Access Compliance Report Public Rights-of-Way (Pedestrian Signals)

Main Street: GILBERT_ST Cross Street: W_ORANGE_AVE Location: SW

ADA ID: SGRK210927112401 Signal Type: One Push Button-Non APS Overall Compliance: No Severity Scores: BTN 1: 25 BTN 2: N/A No BTN: N/A

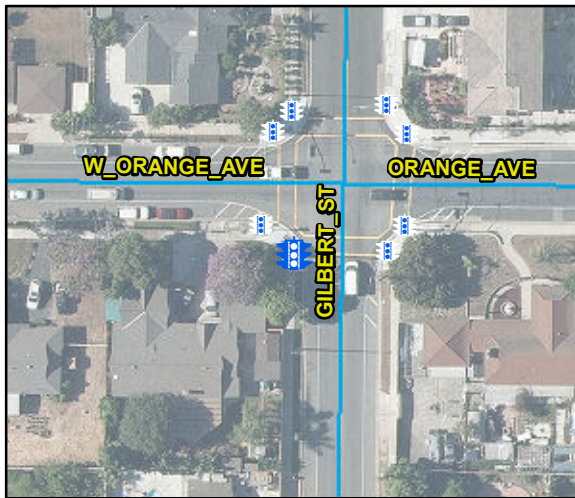
OC Std/PROW: R404.2

Possible Solutions: Remove and Replace Clear Space.
